Our ref: M01616-36

Planning Ref LA01/2025/0181/F - 340m South of 5 Magheraboy Road, Rasharkin

Re: Drainage Assessment- Dfl Rivers Consultation / Policy FLD3

ANNEX A - M01616-36 SK03 Catchment Analysis Figure

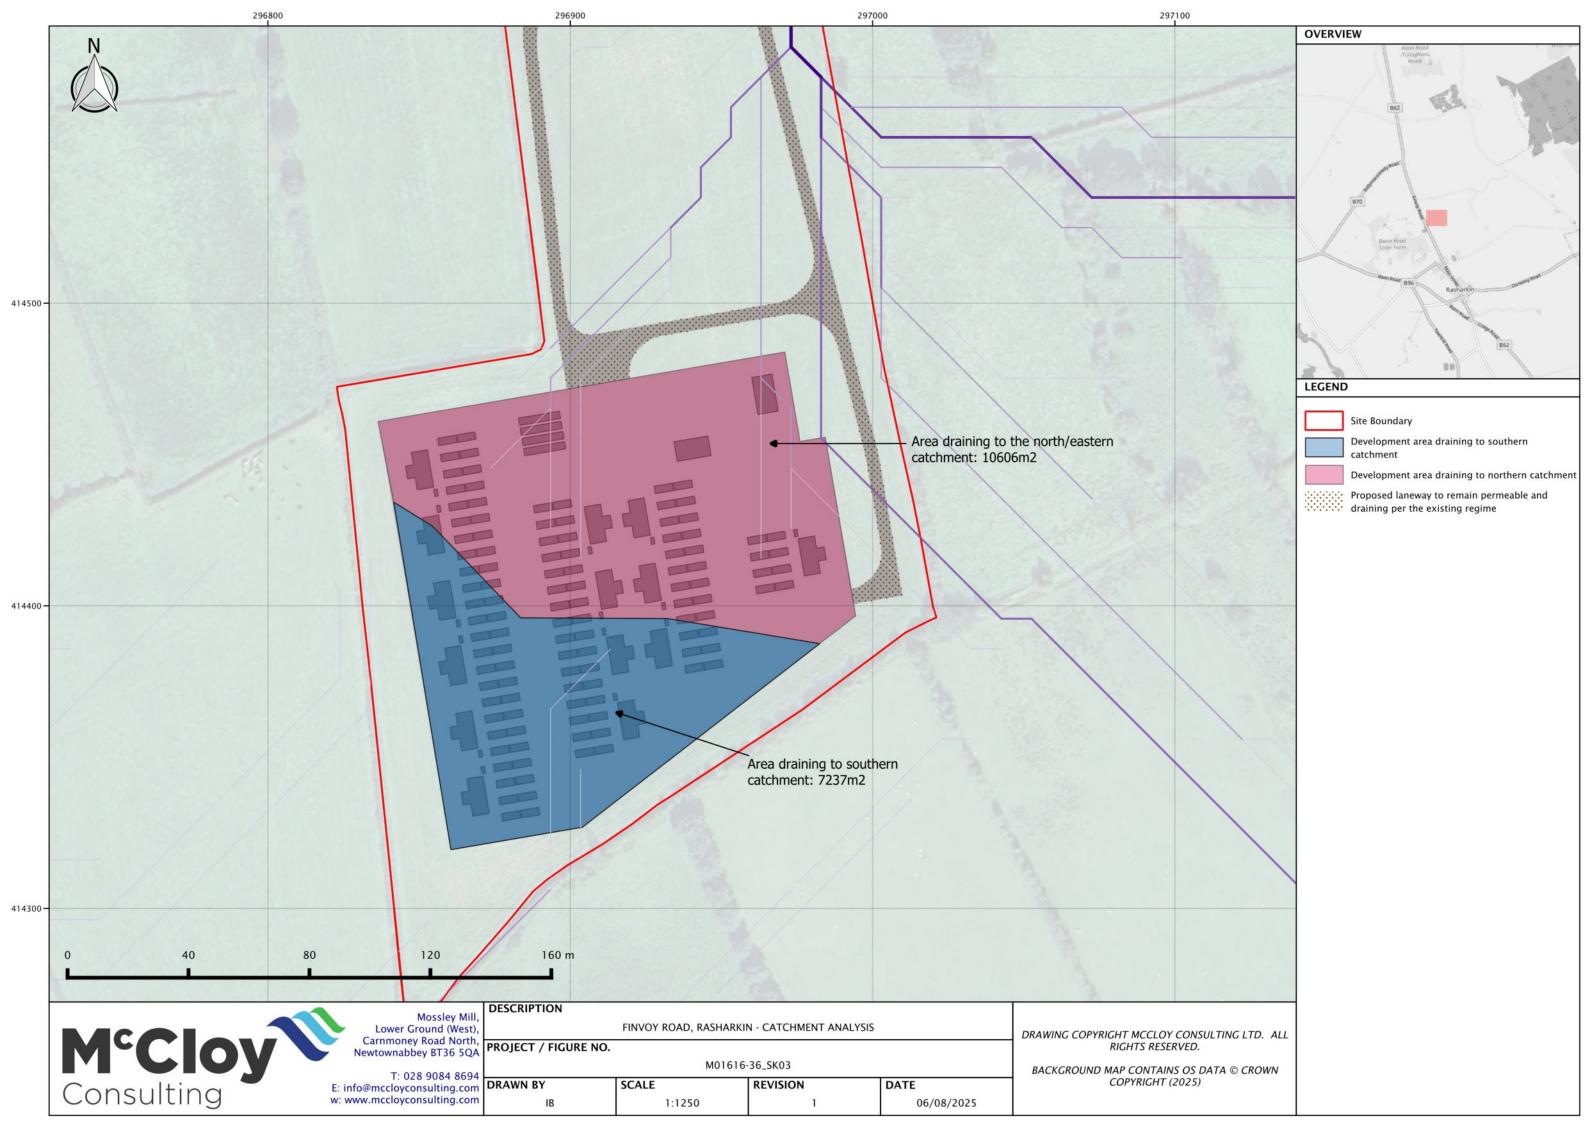
The consultation response requests that it is demonstrated that the total post-development runoff (including the greenfield run-off that is not positively drained in the development's drainage network) which discharges into the undesignated watercourse that runs along the Eastern and northern boundaries of the site, does not exceed the original greenfield run-off in order to prove that there is no increase in flood risk elsewhere as a result of the development.

The response has arisen as a result of the site being affected by a split catchment, where an area of c. 1.63Ha drains south-westerly and an area of c. 4.51Ha drains northeasterly. Dfl Rivers Directorate request demonstration that flow rates to the north-easterly watercourse from the proposed site outfall do not exceed the pre-development greenfield rate of discharge from the site development area to this watercourse.

As such we attach an updated Drainage Plan and Microdrainage Calculations which demonstrate that flows draining to the north-eastern watercourse do not exceed the pre-development flow rates for the north-eastern catchment area only. The below table and figure included in Annex A offers explanation to the updated flow rates. Note that the drainage regime to undeveloped areas within the site shall not undergo changes which will affect run-off rates and the proposed access track shall remain a permeable surface, as such these areas are not considered in Table 1.

The 10.6lps shown on the revised Drainage Plan and associated Microdrainage Calculations has been adopted so that the total discharge from the development area post-development shall be no greater than the equivalent pre-development greenfield rate to the north-eastern catchment area.

There shall be no discharge to the southern catchment from the developed area post-development, which offers a reduction from the current scenario where a greenfield rate of run-off would apply from the area currently draining south.
